# NEWGEN POWER STATION KWINANA

## MARINE ENVIRONMENT TEMPERATURE ELEVATION MANAGEMENT PLAN (METEMP)

Amended September 2014

A draft copy of the METEMP was circulated to designated stakeholders for comment. The following comments were received. NewGen responses are in italics.

**Figure 1 Location of other diffusers (solid lines) and intakes (black circles) adjacent to NewGen Power diffuser (yellow). White line is the boundary of the LEPA, mixing zones indicated by dashed lines.**

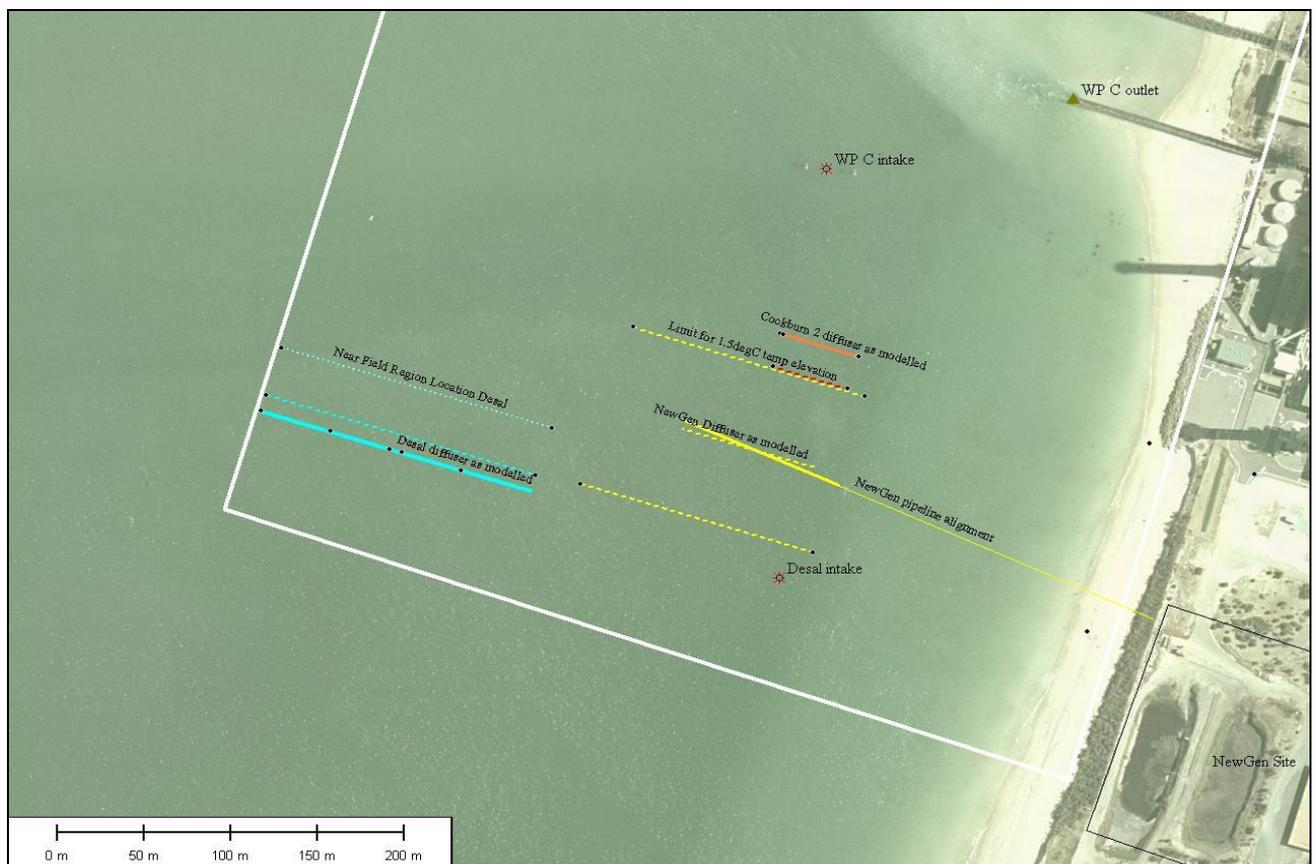
S 6 Design/construct - Figure 1: Cockburn 2 intake will be the same as Kwinana, Cockburn 1 and NewGen. The last para is tending to indicate that Cockburn 2 will have its own inlet pipe.

S 6. Design/construct - Figure 1: It is understood that the Desal Plant outlet had been located a further 500 metres off shore. Could the location of this outlet be confirmed?

Figure 1.0 – need to put the mixing zones on the map – i.e 50m for PSDP1 and 25m? for NewGen and whatever the mixing zones are for the other discharges in the LEPA.

*The location is as shown in Figure 1.*

**Figure 2 NewGen Diffuser Performance Monitoring Schematic**

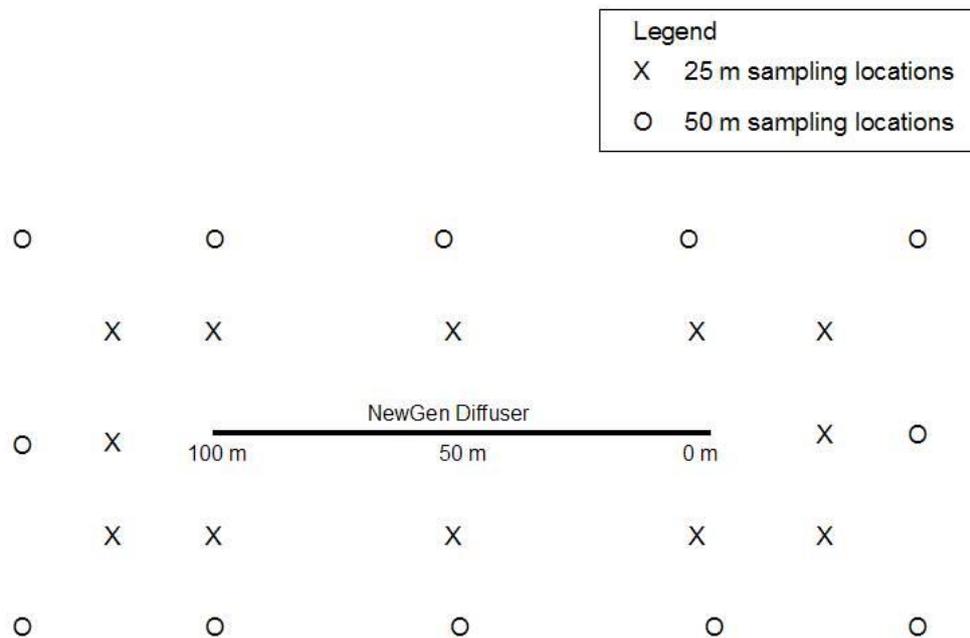
Figure 2 – should overlay this over an aerial and include the criteria show it is visually demonstrated.
